AMENDMENTS TO THE DRAWINGS

The six attached sheets of formal drawings include changes to Figure 5 and Figure 7. These sheets, which include Figures 1-7, replace the original sheets including Figures 1-7.

FIG. 5

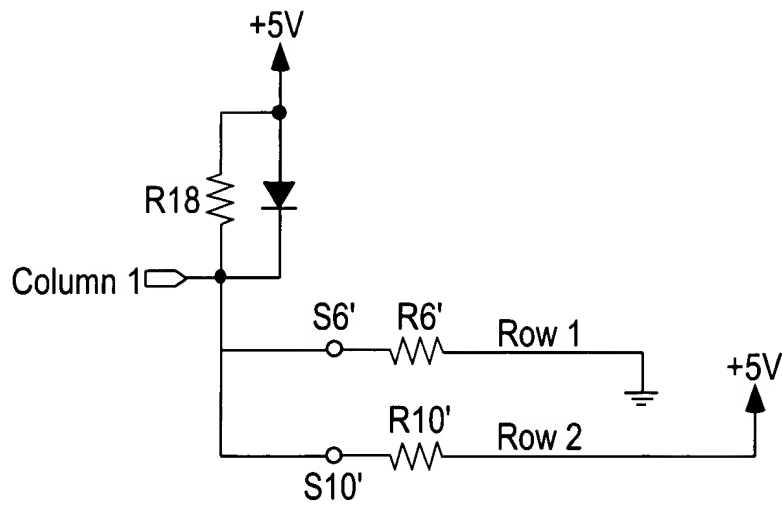
In Figure 5, switches S6' and S10' have been drawn closed to reflect the description of Figure 5 that begins at page 6, line 17 of the specification.
